Addendum No.: 3

Date Of Addendum: June 16, 2017

CT DAS • Construction Services • Process Management and Procurement Unit

Capitol Area System (CAS) Extension
101 Lafayette Street
Hartford, CT 06106
BI – 2B – 393

AI Engineers, Inc. <small>819 Misco Street Middletown, CT 06457 Telephone: 860-355-7172 Fax: 860-355-7172 www.aiengineers.com</small>	DATE: 06-12-17 SCALE: NTS DRAWN BY: CSG CKD BY: RMD	101 LAFAYETTE ST. CAS SYSTEM EXTENSION HARTFORD, CT CIVIL DETAILS
	SKC2.01-1

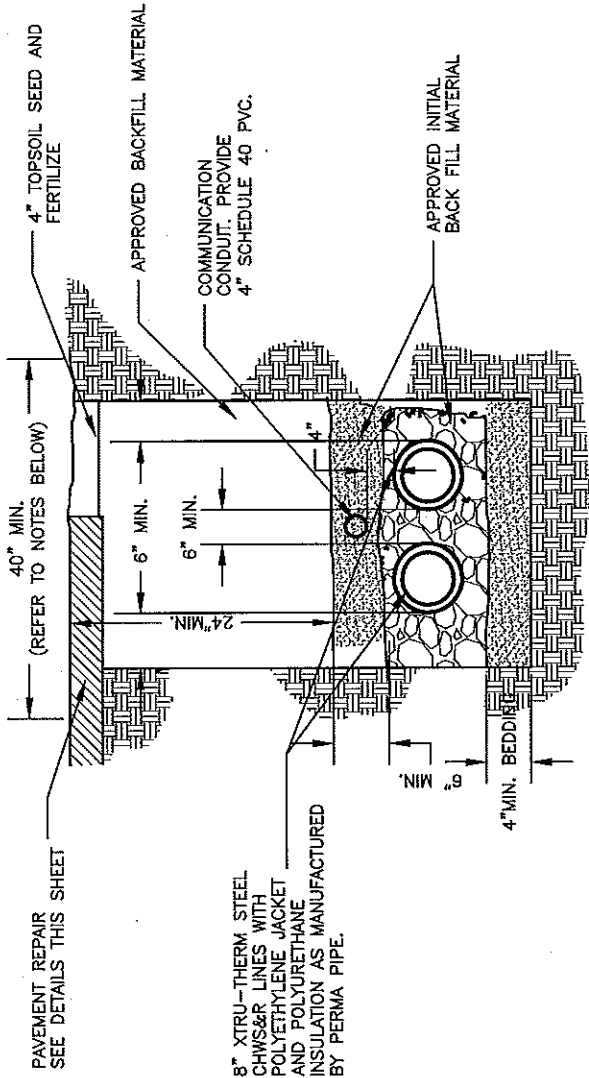
The trench details have been modified to address the two trench conditions on this project. Refer to attached sketches SKME1.00-1 and SKC2.01-1.

NOTES:

1. DETAIL DEPICTS TWO PIPE TRENCH CONDITION (CHILLED WATER SUPPLY AND RETURN ONLY).
2. FOUR PIPE TRENCH CONDITION ALSO OCCURS ON THIS PROJECT (CHILLED WATER SUPPLY AND RETURN AND HOT WATER SUPPLY AND RETURN).
3. MINIMUM TRENCH WIDTH FOR FOUR PIPE CONDITION IS 72".
4. SPACING BETWEEN PIPES IN ALL CONDITIONS IS 6" MINIMUM.
5. SPACING BETWEEN PIPES AND EDGE OF TRENCH IN ALL CONDITIONS IS 6" MINIMUM.
6. TRENCH WIDTH WILL VARY AT PIPE ANCHOR AND EXPANSION COMPENSATION LOCATIONS. COORDINATE WITH APPROVED MANUFACTURER'S LAYOUT DRAWINGS.
